# UNITED STATES PATENT AND TRADEMARK OFFICE

APPLICATION NO.	FILING DATE	FIRST NAMED INVENTOR	ATTORNEY DOCKET NO.	CONFIRMATION NO.
10/782,961	02/23/2004	Shinya Marushima		7569

**Office Action Summary**

**DETAILED ACTION**

Figures 4A, 4C of Carreno.

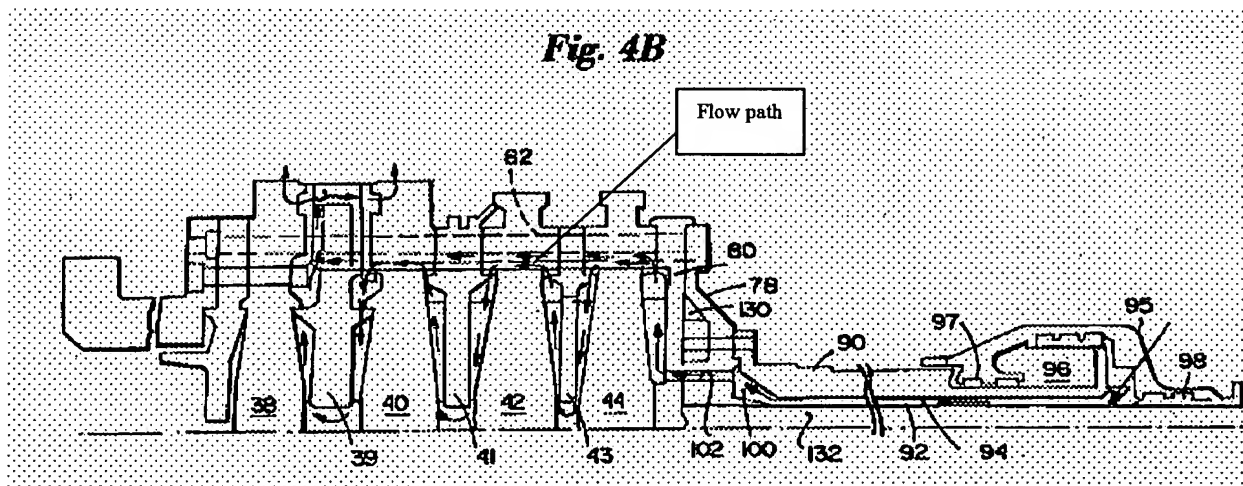
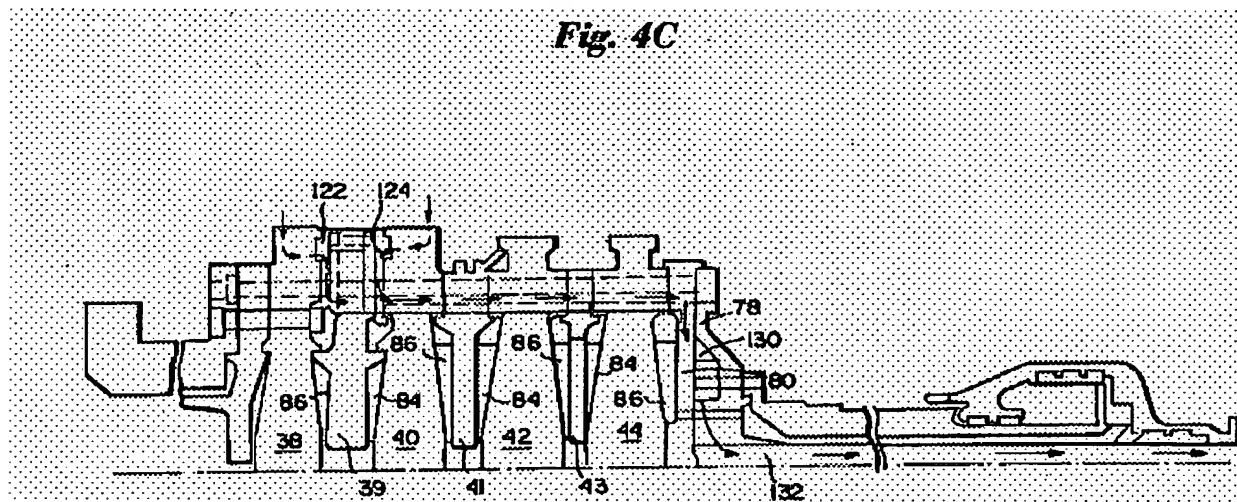
Claim 16 is rejected under 35 U.S.C. 102(b) as being anticipated by **Carreno et al. (U.S. 5,593,274)**

**Carreno** teaches a gas turbine which a rotor shaft comprises a plurality of discs 38, 40, 42, 44 each having a plurality of moving blades arranged annularly on the peripheral portion, and spacers 39, 41, 43 arranged between said discs, said respective discs 38, 40, 42, 44 and spacers 39, 41, 43 being arranged in an axial direction in turn, comprising: gap portions 84, 86 formed between rotor axis side regions of said discs 38, 40, 42, 44 facing said spacers 39, 41, 43 and adjacent spacers; a supply flow path 92 for supplying refrigerant for cooling to said moving blades and a recovery flow path 132 for recovering heated refrigerant, each of said supply and recovery flow paths being provided in said rotor shaft; a flow path (see Figure 4B) for introducing fluid into said gap portions 84, 86 provided in said discs (see particularly **Figures 4B, 4C** of **Carreno**

above), wherein said recovery flow path is arranged on a more radially inner side than said supply flow path, and wherein the fluid introduced into said gap portions is exhausted therefrom into a gas flow path of said gas turbine.
